Gibbons Creek Environmental Redevelopment Group, LLC

September 6, 2022

Re: Technical NOD2 New CCR Registration  
Gibbons Creek Environmental Redevelopment Group, LLC – Anderson, Grimes County  
New Coal Combustion Residuals (CCR) Registration No. CCR113  
Industrial Solid Waste Registration No. 32271  
EPA Identification No. TXD000751073  
Tracking No. 27262344; RN100214550/CN6505860162

TMPA DRAWINGS

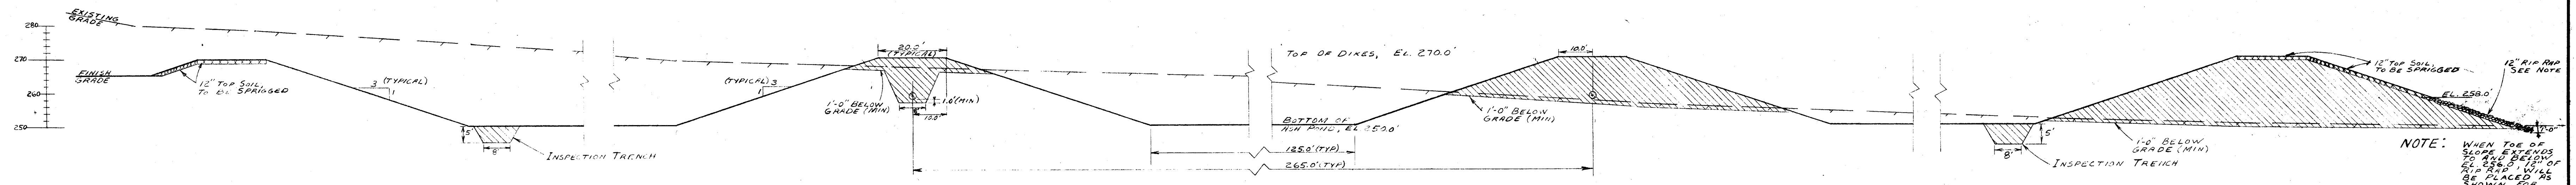
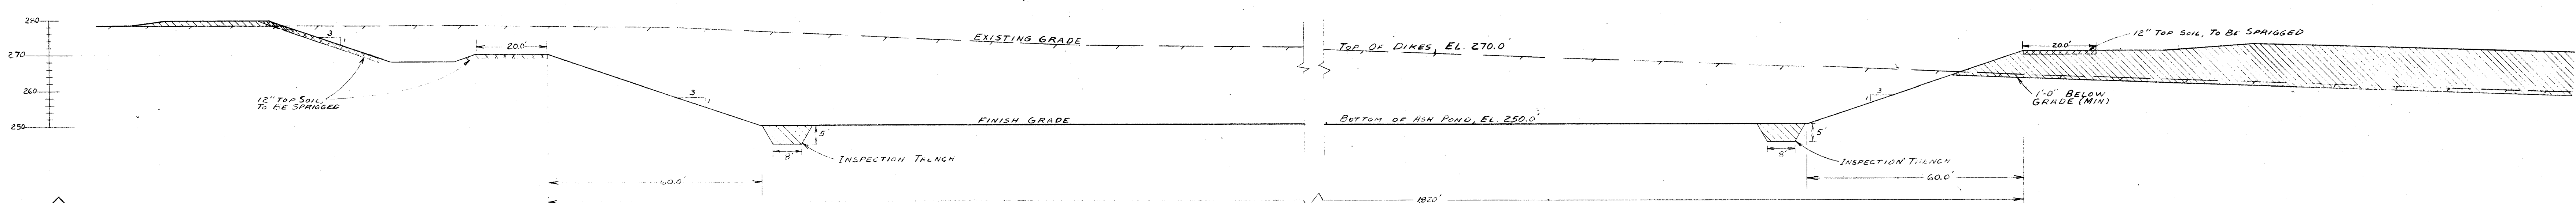
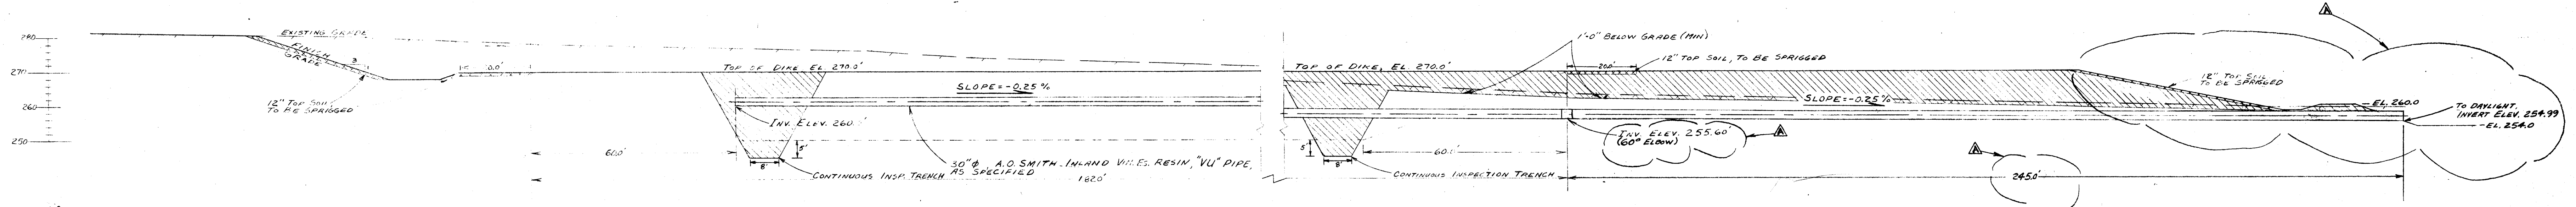
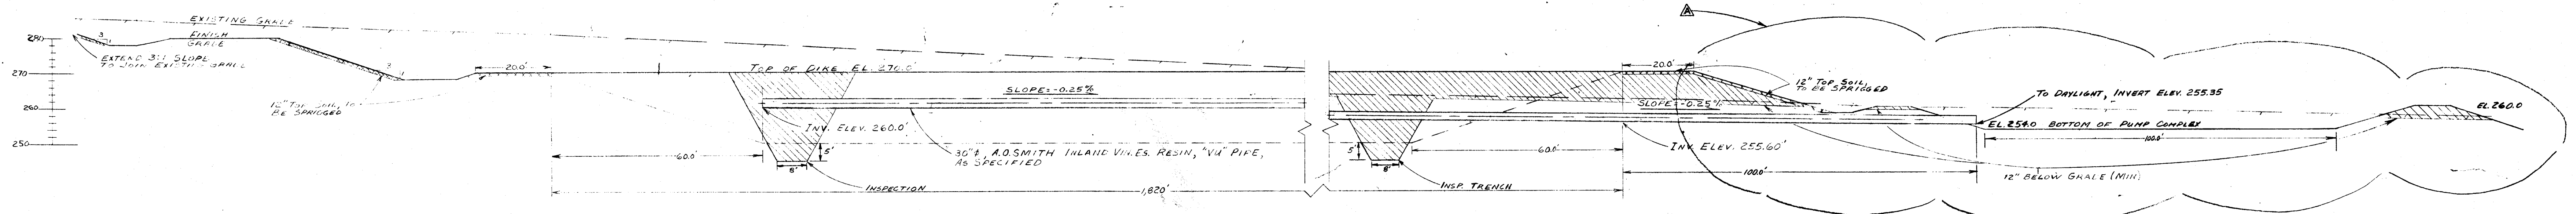
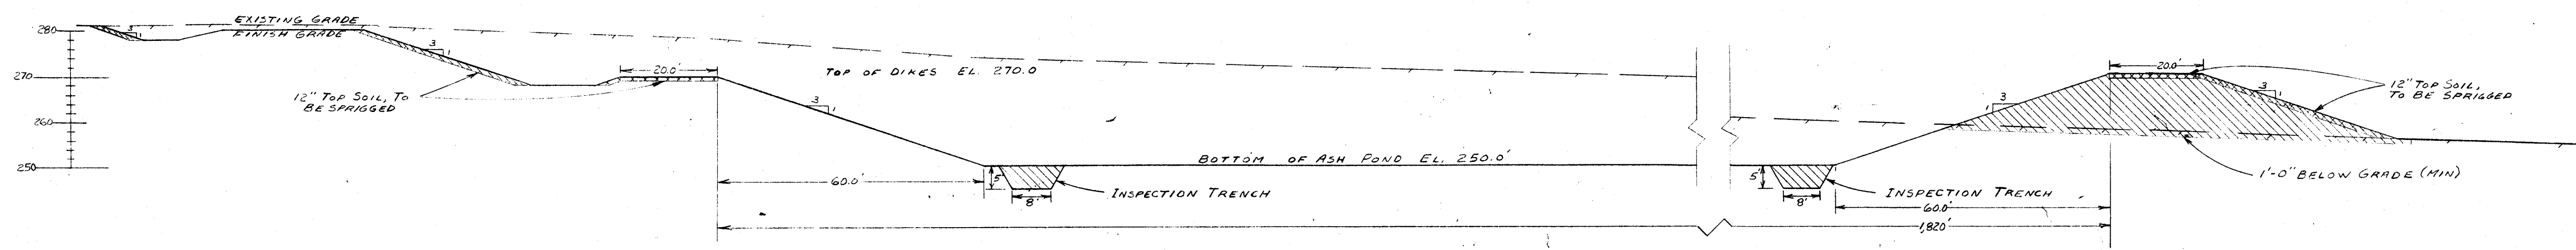
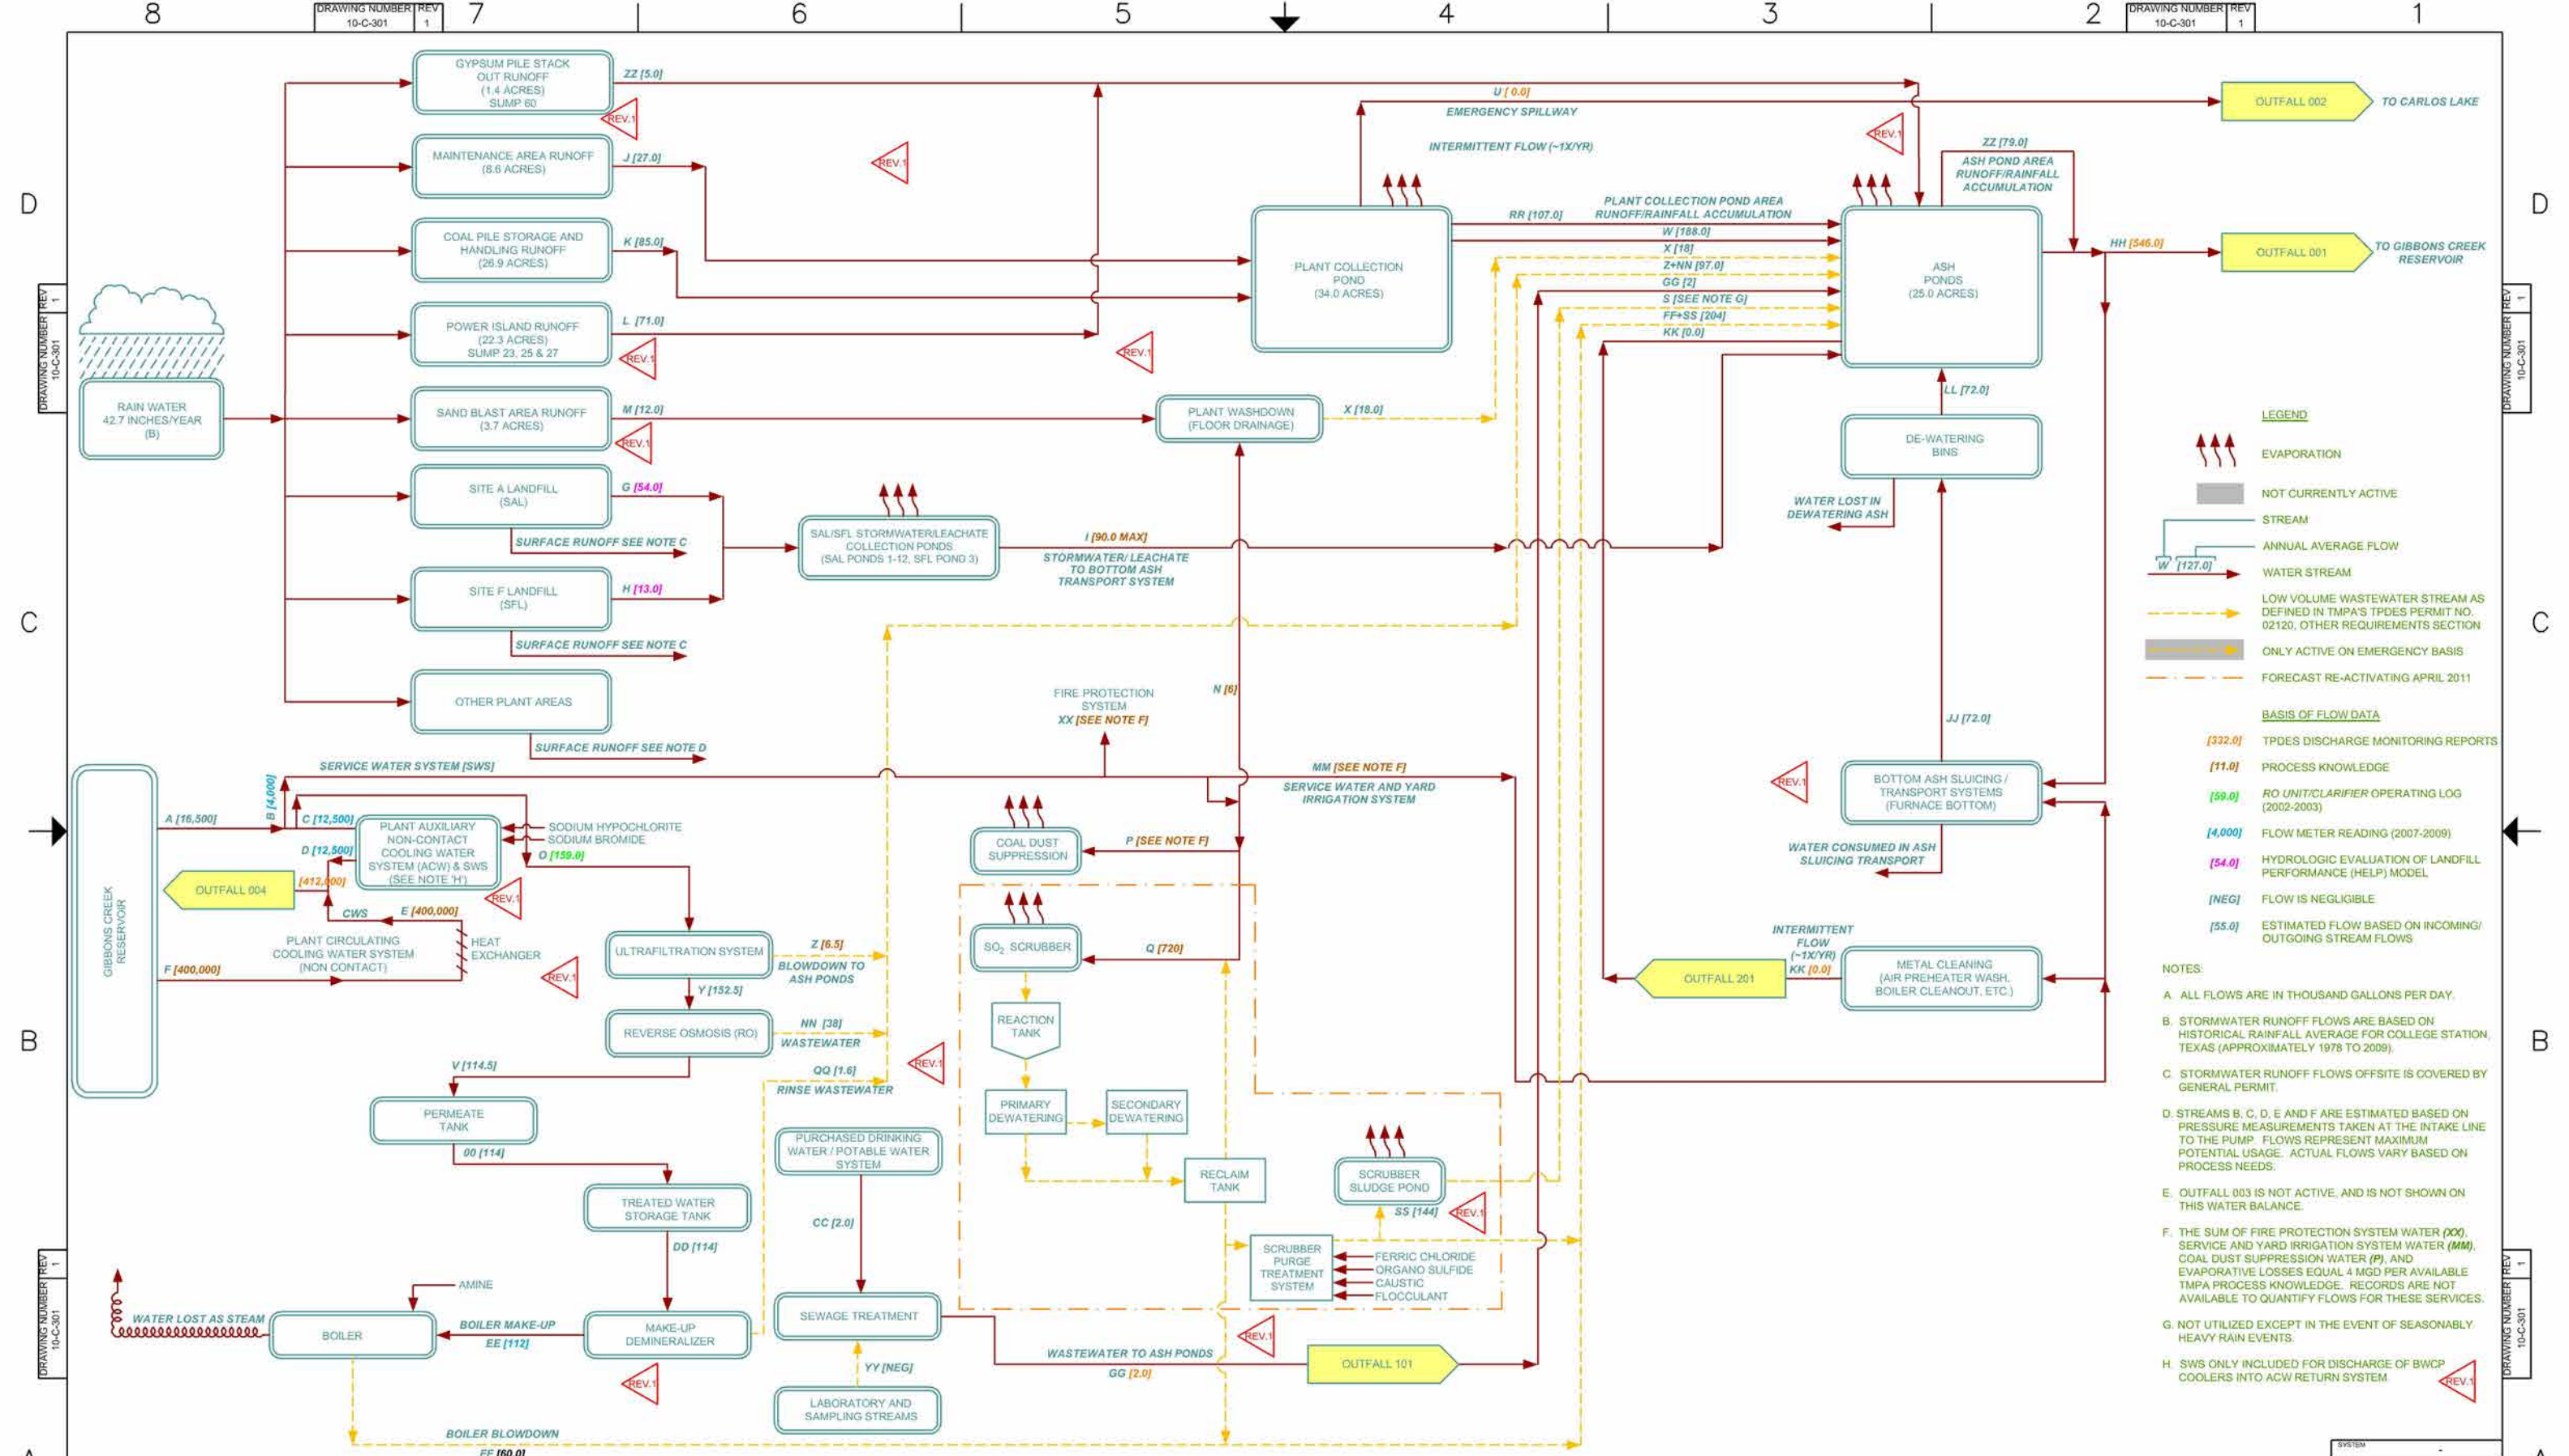
Provide reference locations for TMPA drawings.

*See Response Item 24 Attachment for referenced TMPA drawings.*

UPDATED ADJACENT LANDOWNER LIST AND DRAWING

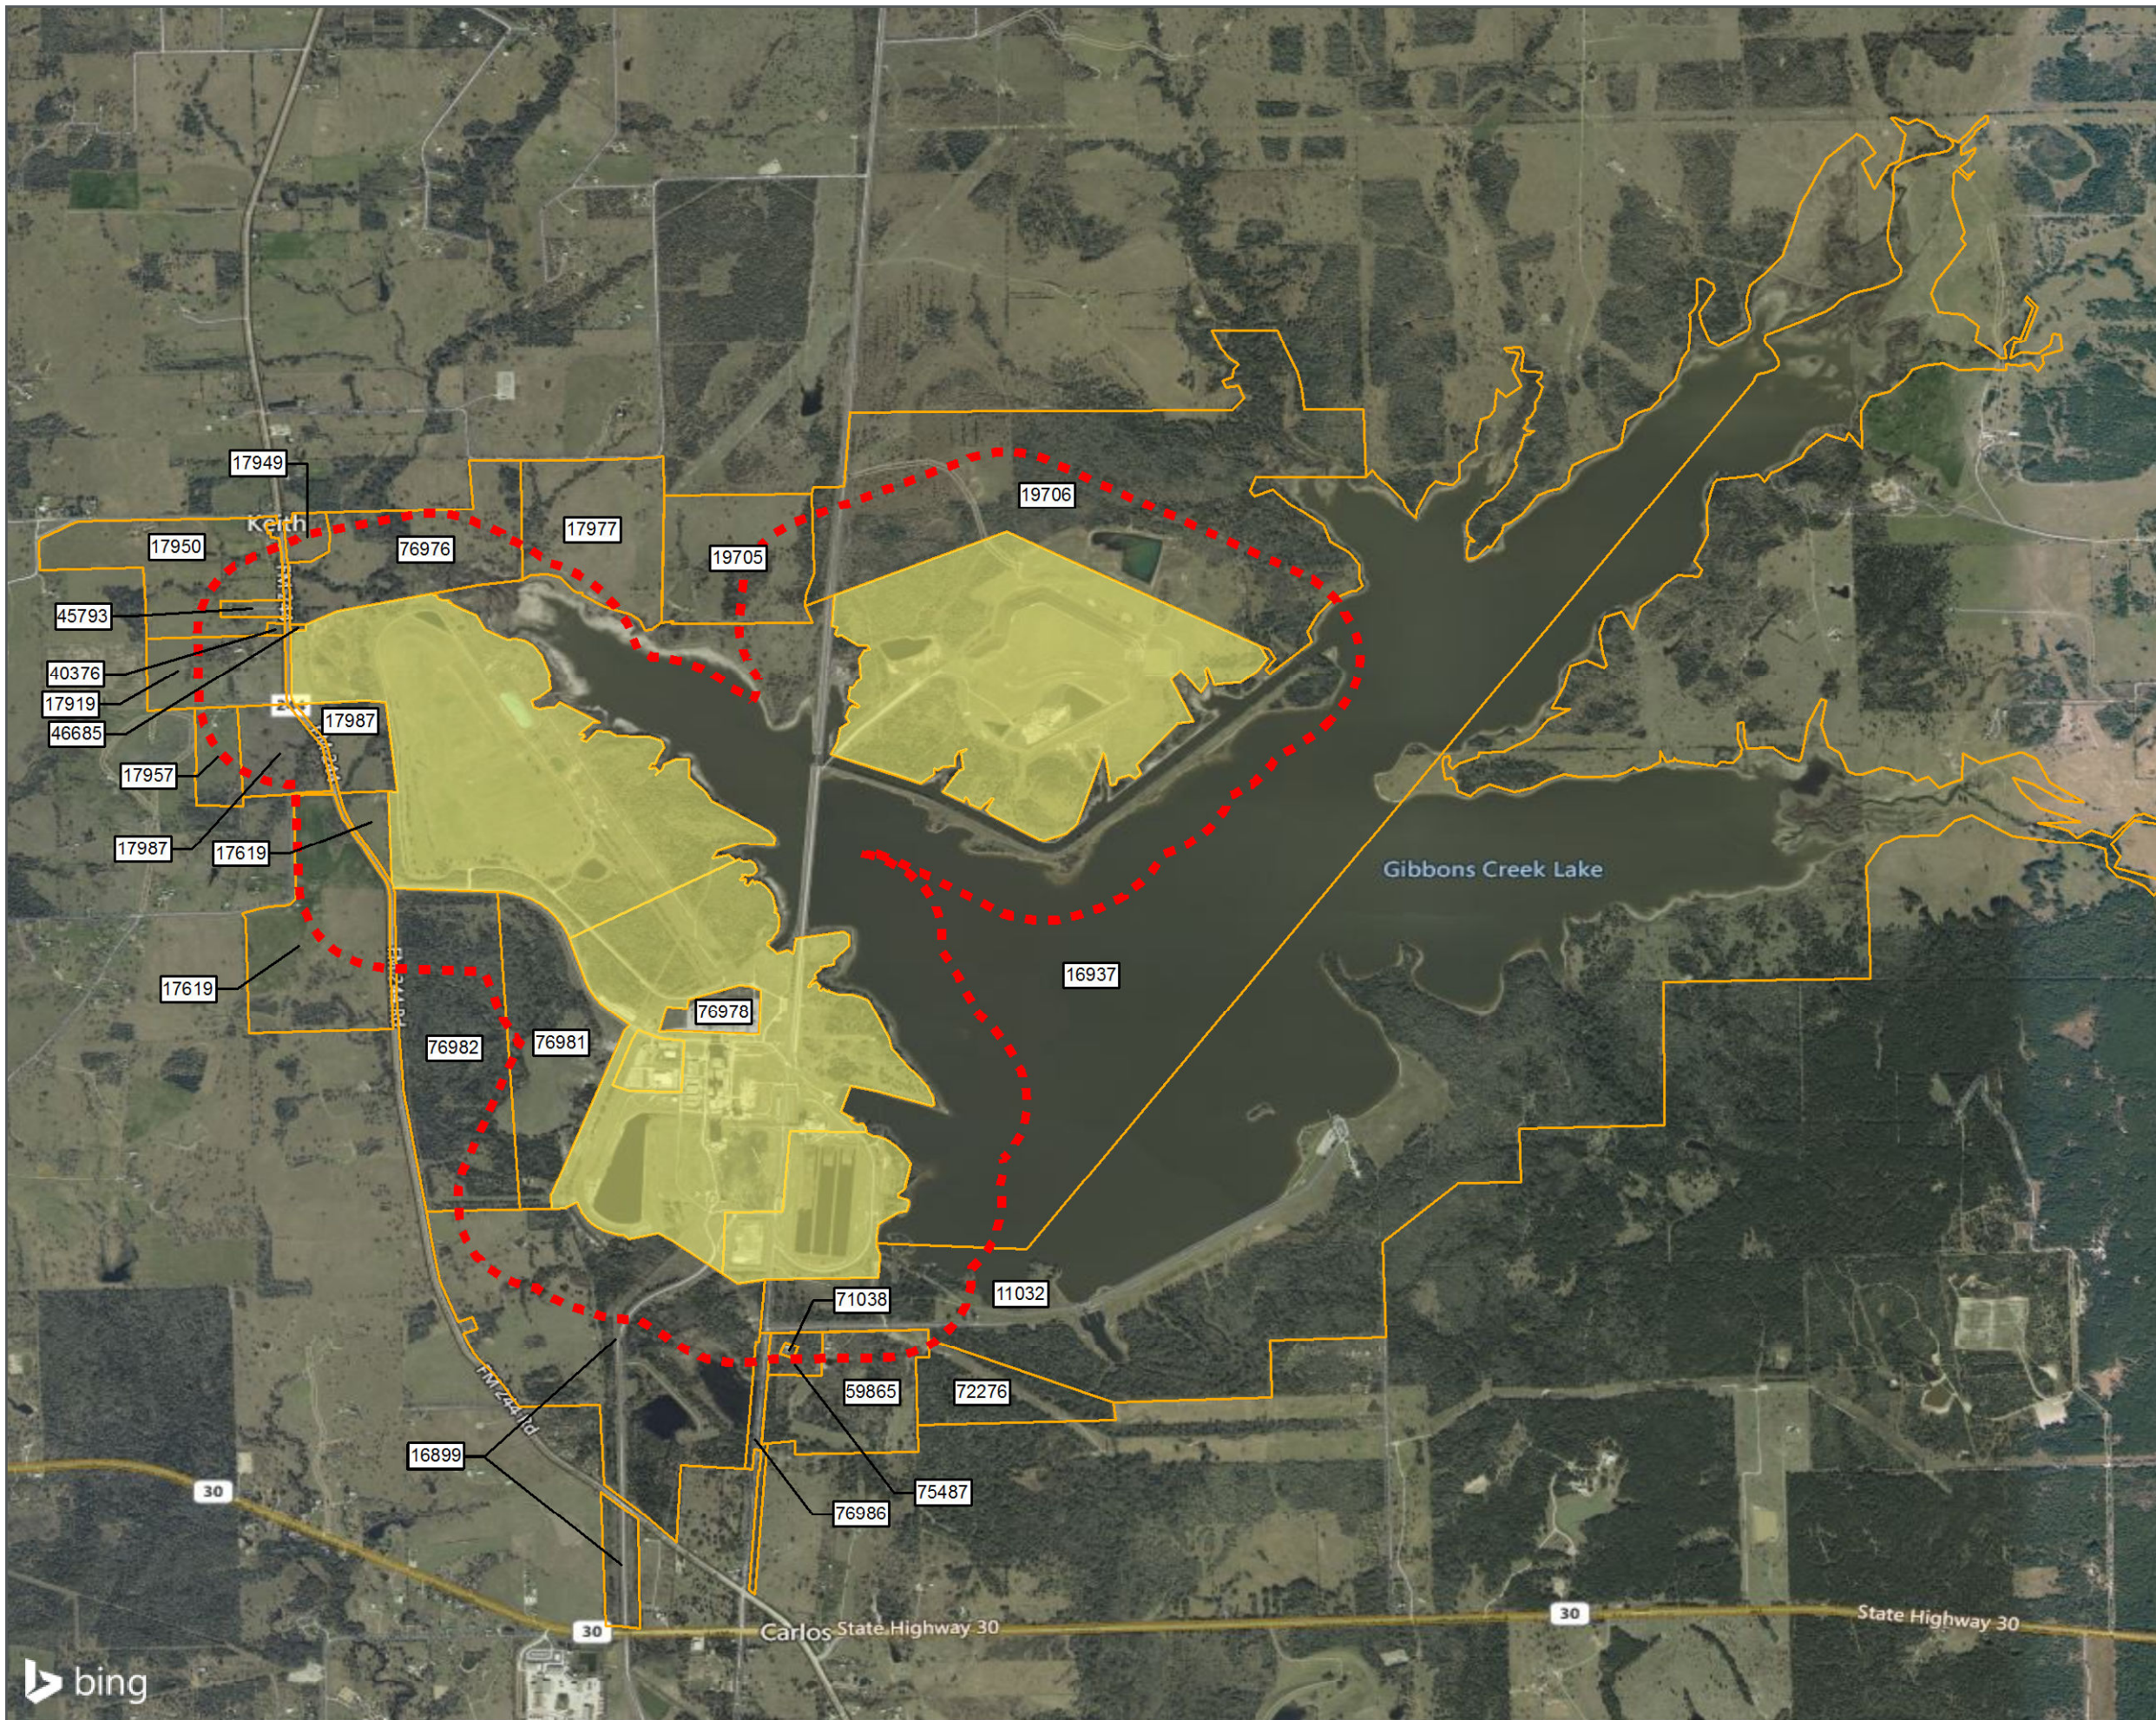
Provide updated adjacent landowner list and drawing, and pre-printed mailing labels after selling off portions of the property. Additionally, include mineral interest ownership information.

*Please see Response Item 10 (2) for a revised adjacent landowner list and drawing. Pre-printed mailing labels will be sent separately to the TCEQ.*
